**To:** Planning Committee  
**From:** Victor Wei,  
Director, Transportation  
Terry Crowe,  
Manager, Policy Planning  
**Date:** October 10, 2017  
**File:** 08-4045-20-04/2017-  
Vol 01  
**Re:** **Proposed Changes: Steveston Area Plan, Village Heritage Conservation Policies, Design Guidelines and Long-Term Bayview, Moncton and Chatham Street Visions**

**Richmond Official Community Plan Bylaw 7100  
Amendment Bylaw 9775  
Steveston Area Plan (Schedule 2.4)**

Typical Cross-Section of Recommended Streetscape Design for Bayview Street

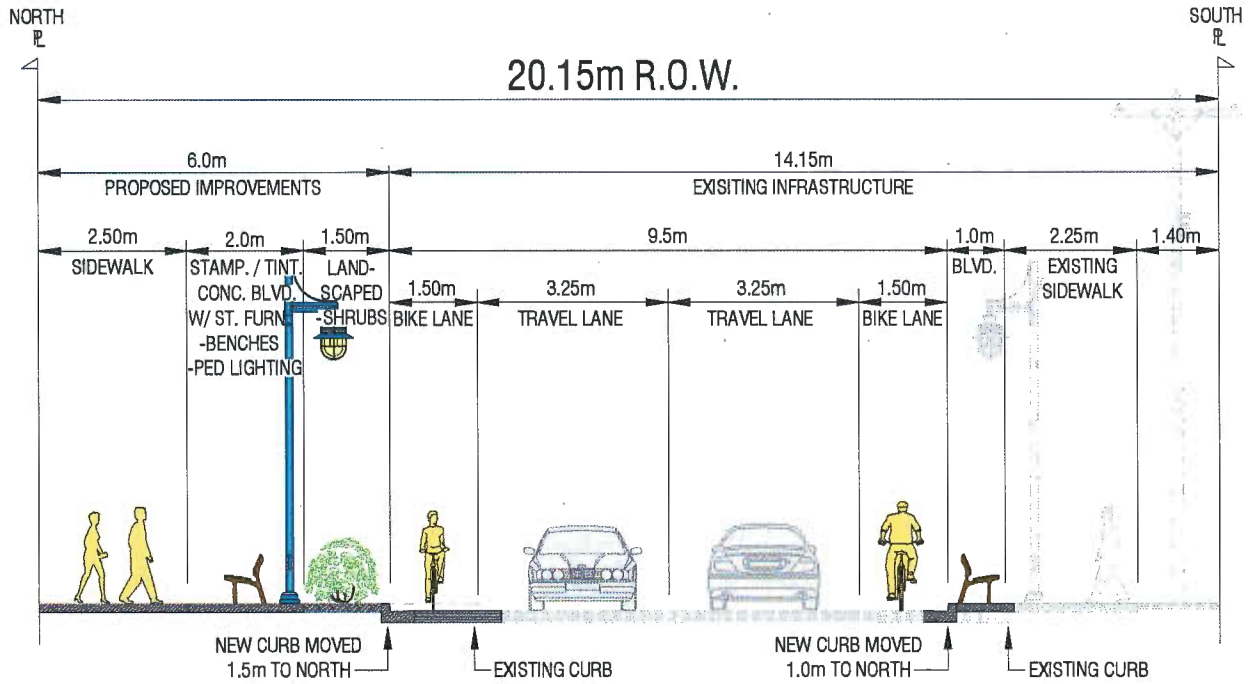
Attachment 9 illustrates a typical cross-section and plan view for the recommended modified Option 3 for Bayview Street. Attachment 10 indicates that recommended streetscape option could be implemented along the majority of both sides of the street (yellow shaded areas) with the exception of two areas where there would be private property impacts (pink shaded areas).

**Existing and Future Riverfront Walkways and Connections**

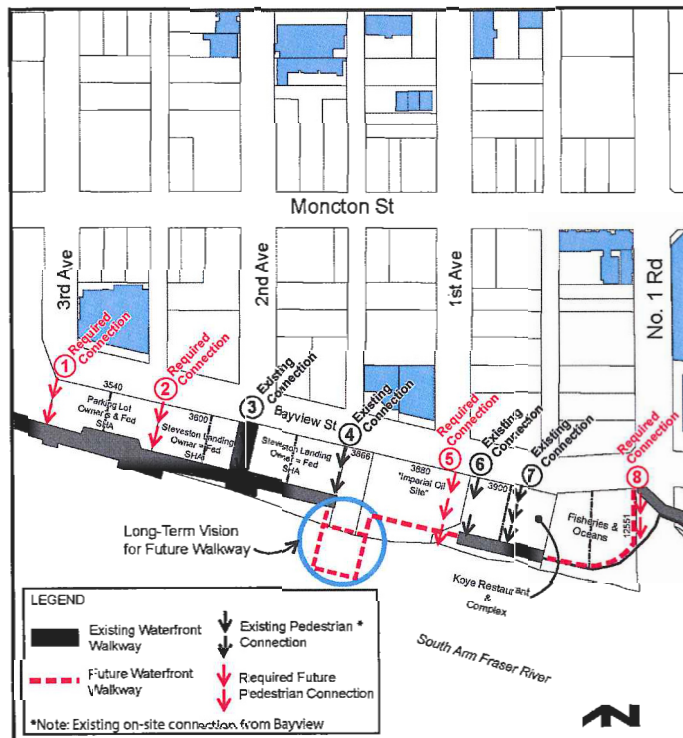
- v) Adding the following text into Section 6.0 Natural & Human Environment and accompanying diagrams:

“Objective 6: Work toward public accessibility for pedestrians to and along the waterfront between 3<sup>rd</sup> Avenue and No. 1 Road through pathways that connect Bayview Street to the water’s edge, and completion of a continuous boardwalk.

- a) Work with the Federal Government, Steveston Harbour Authority and other property owners to establish new pedestrian connections at the following street and lane ends.
  - Pedestrian connections at road ends at the south foot of No. 1 Road, 1st Avenue and 3rd Avenue will meet the following guiding principles for universal accessibility and urban design:
    - Create a public right-of-passage with a minimum width of 5.6 m including 1.0 m setbacks from adjacent buildings
    - Building signage projections up to 1.0 m into any building setback and detailed as per Steveston Development Permit Area Design Guidelines

**Steveston Village Character Area Map**

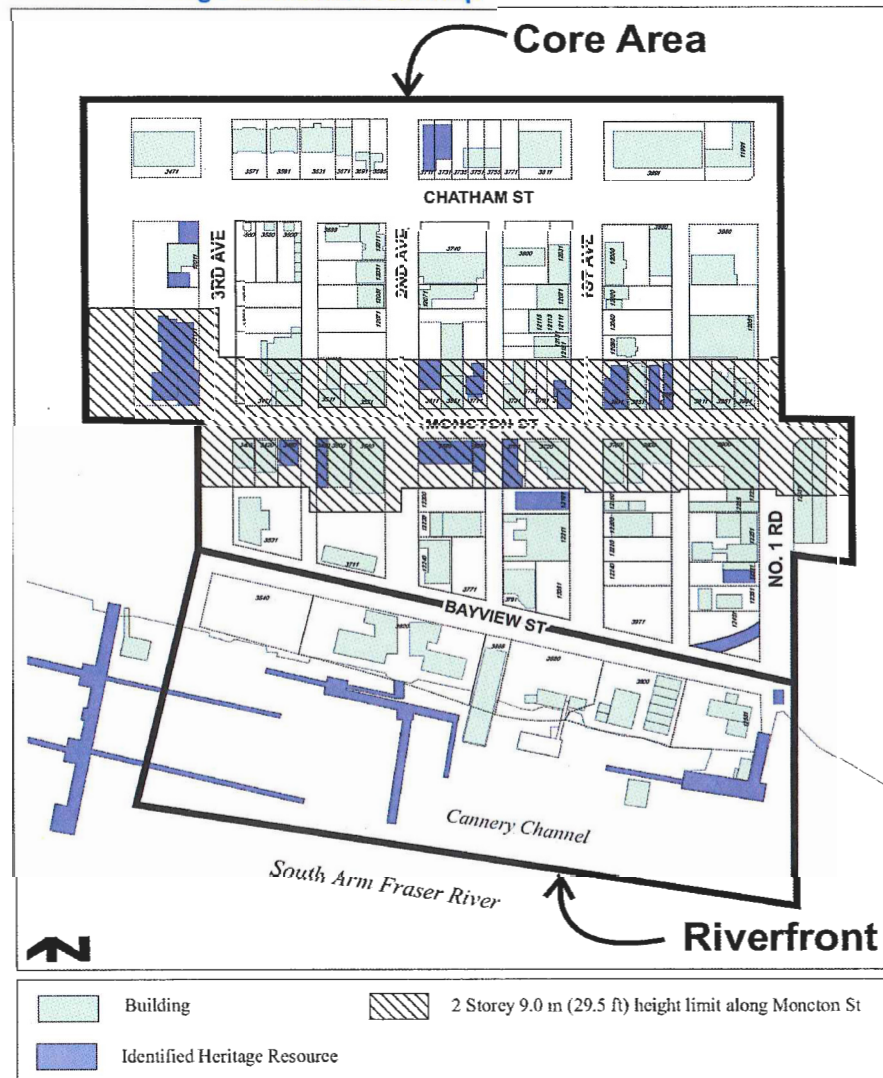
vi) In Section 9.3 Additional Development Permit Guidelines: Character Area Guidelines, repeal and replace the Steveston Village Character Area Map as follows:

- vii) Inserting the following text to Section 9.3.2.1 Steveston Village General Guidelines: Shifts in Scale:
- “e) Existing elevations in the Village Core (at Moncton Street and 3<sup>rd</sup> Avenue), measured at 1.4 m GSC (Geodetic Survey Datum of Canada) is a historic feature in the Steveston Village Character Area to be retained:

- For properties in the Steveston Village Core, north of Bayview Street, the higher elevation of 1.4 m GSC or of the existing adjacent sidewalk shall be used and referenced in the development.

**Steveston Village Land Use Density and Building Height Map**

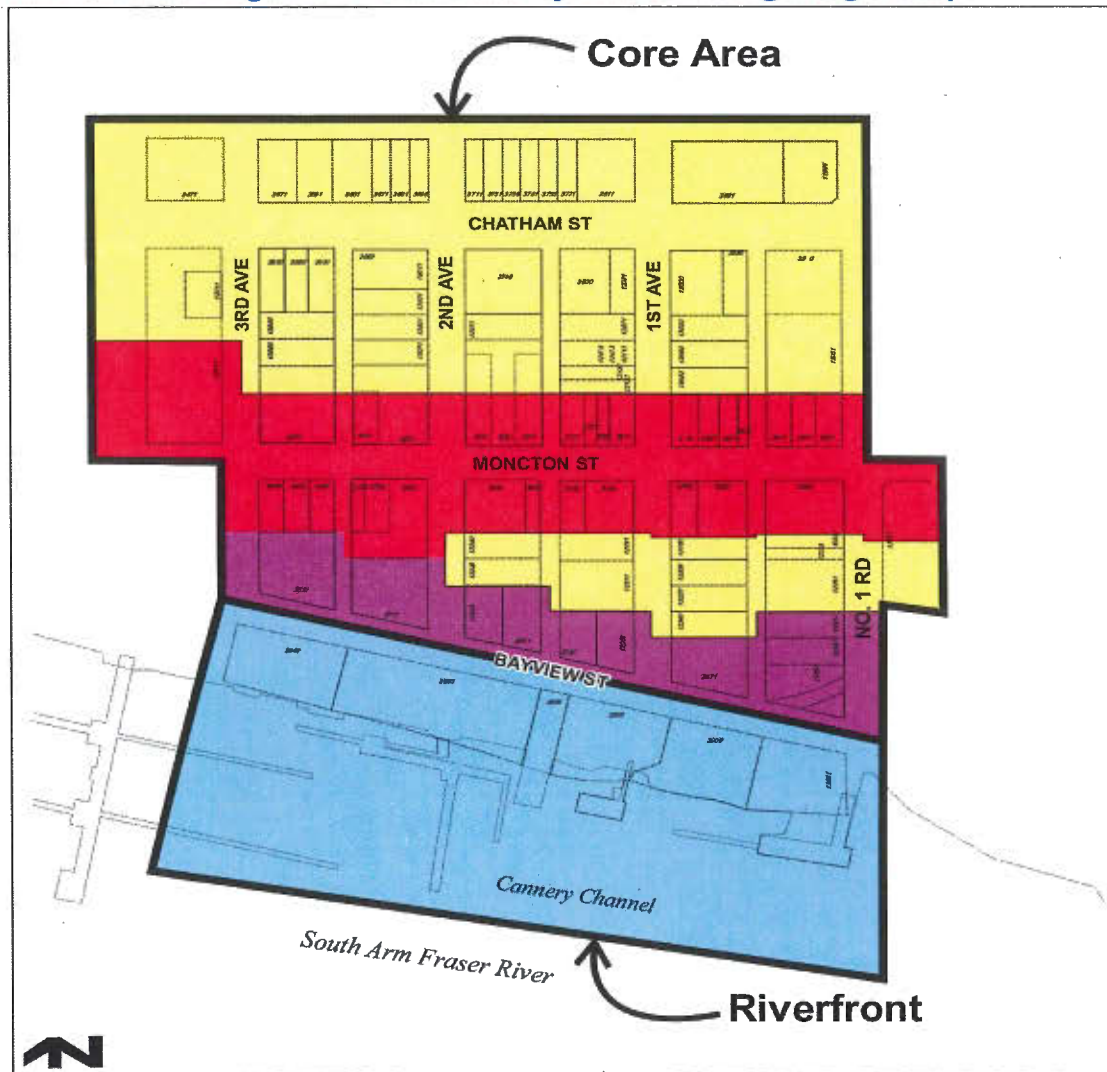
- xiv) Repeal and replace the Steveston Village Land Use Density and Building Height Map as follows:

Maximum FAR	Maximum Storeys	Maximum Building Height
Core Area, generally	1.6	3	12 m *
Core Area, Bayview Street (North)	1.2	3**	Varies due to grade elevation difference north of Bayview Street
Moncton Street **	1.2	2	9 m *
Riverfront Area	1.6	3	20 m GSC ***

\* Maximum building height may increase where needed to improve the interface with adjacent existing buildings and streetscape, but may not exceed the maximum storeys.
